## **2020 STANDARD DETAILS** **Summary of Changes**

## POLE DETAILS D-702

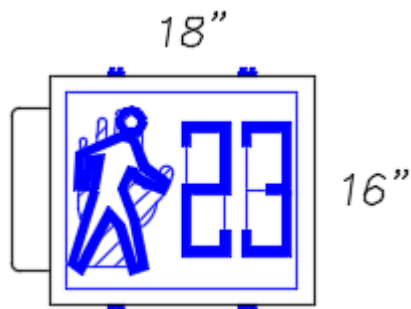
1. Revised Note 1 to the following; *THE ALUMINUM LIGHTING STANDARD INCLUDING ANCHORAGE WITH LUMINAIRE PROPERLY INSTALLED SHALL BE IN ACCORDANCE WITH THE 2013 AMERICAN ASSOCIATION OF HIGHWAY AND TRANSPORTATION OFFICIALS (AASHTO) FOR 90 MPH WIND AND A LUMINAIRE SIZE OF 1.3 SQ. FT. MIN. EFFECTIVE PROJECTED AREA WEIGHING 55 LB. MIN.*
2. Revised Table 1 Designations;
  - 30 –A-10 to 30-B-10
  - 30-A-10-10 to 30-B-10-10
  - 40-A-10 to 40-B-10
